PIC16F13145 Family Silicon Errata and Data Sheet Clarifications

PIC16F13145 Family

The PIC16F13145 devices that you have received conform functionally to the current device data sheet (DS40002519C), except for the anomalies described in this document.

Figure 1-1. Project Properties "Fill Flash Memory" Option Category Window View

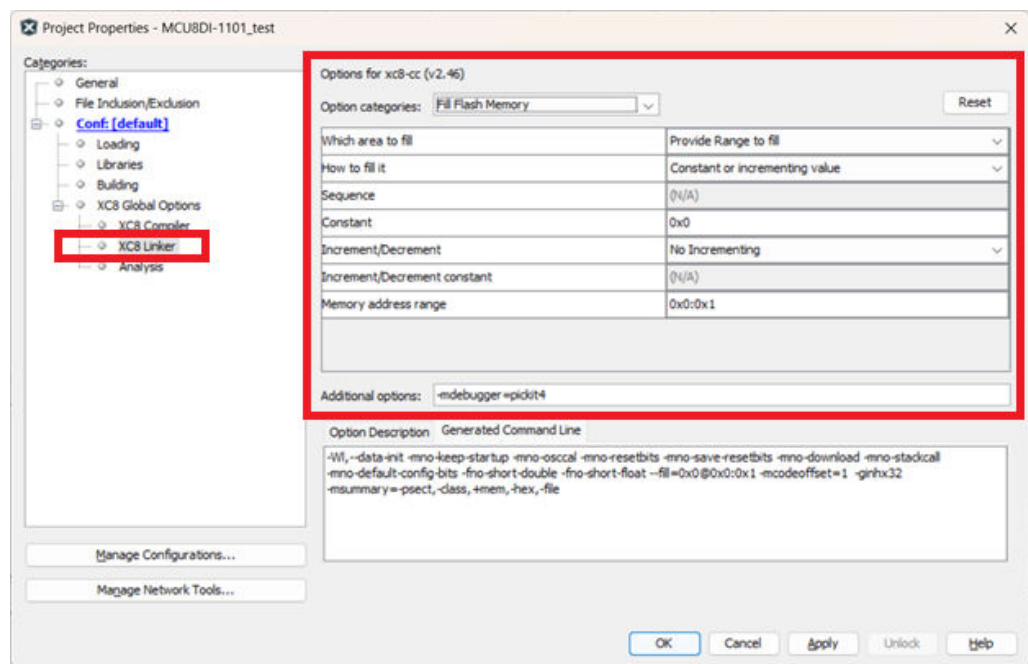
1.3.1 The First Instruction Fetch by the CPU Under Certain Conditions Will Fail

The first instruction fetch by the CPU will fail immediately after Power-up, a device Reset, waking up from Sleep, or jumping into an Interrupt Service Routine (ISR). This failure occurs when the device frequency is above 16 MHz ($F_{OSC} > 16$ MHz).

Option 2: If the device must operate above 16 MHz:

- Open the **Project Properties** window (see [Figure 1-1](#)), and under the **XC8 Linker** categories tab, fill in the information as shown below:
In the **Option categories** drop-down menu, select **Fill Flash Memory**:
 - In the **Which area to fill** field, select **Provide Range to fill**
 - In the **How to fill it** field, select **Constant or incrementing value**

- In the **Constant** field, enter **0x0**
- In the **Increment/Decrement** field, select **No Incrementing**
- In the **Memory address range** field, enter **'0x0:0x1**
- In the **Additional options** field, enter `-mdebugger=type`, where *type* is the type of debugger tool used for programming/debugging the device as defined in the table below:
